Customer Advisory Letter

05/05/2021 CAL FTL 32-011

Subject: 80KSI Frame Reinforcement Installation

Models Affected: Specific Freightliner M2 vehicles manufactured between April 26, 2016 and April 1, 2020 equipped with 80KSI frame rails and an Airliner 20,000 lb or 21,000 lb rear suspension

Fig. 1, View From Inside of Right-Hand Rail

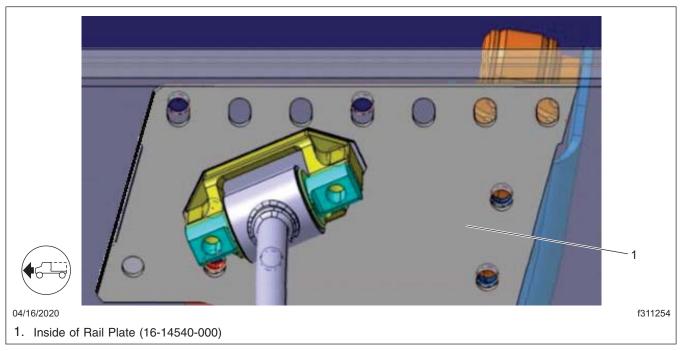
Replace the existing reinforcement plate located at the rear suspension track rod frame bracket with a larger reinforcement plate as outlined in the following instructions.

- 8. Align the inner reinforcement plate (16-14540-000) with the shock bracket mounting holes on the inside of the right-hand frame, then attach the shock mounting bracket to the frame and inner reinforcement plate using the two 2 in long 5/8 in bolts, nuts, and washers. See **Fig. 1.** Tighten the bolts hand tight only.
